## Rubber Retainer-Bleed Check Valve – 1990 Mariner/Mercury 75-115

This is a revision of Outboard Service Bulletin 90-2. Destroy Bulletin 90-2 and insert Bulletin 90-2A. Revisions are underlined.

Figure 1. Bleed Check Valve Location

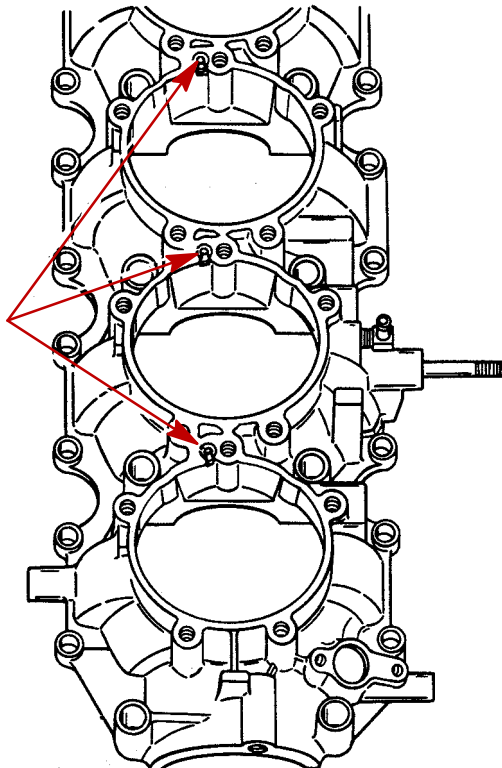
Rough running at idle may be caused by an improperly formed rubber retainer that holds the bleed check valve. (Figure 1) Improperly formed rubber retainers have a thin piece of rubber covering the opening (Figure 2) which prevents circulation of puddled fuel. The opening must be clear for the bleed system to operate properly. Retainers are now inspected before installation in the engine after serial numbers listed.
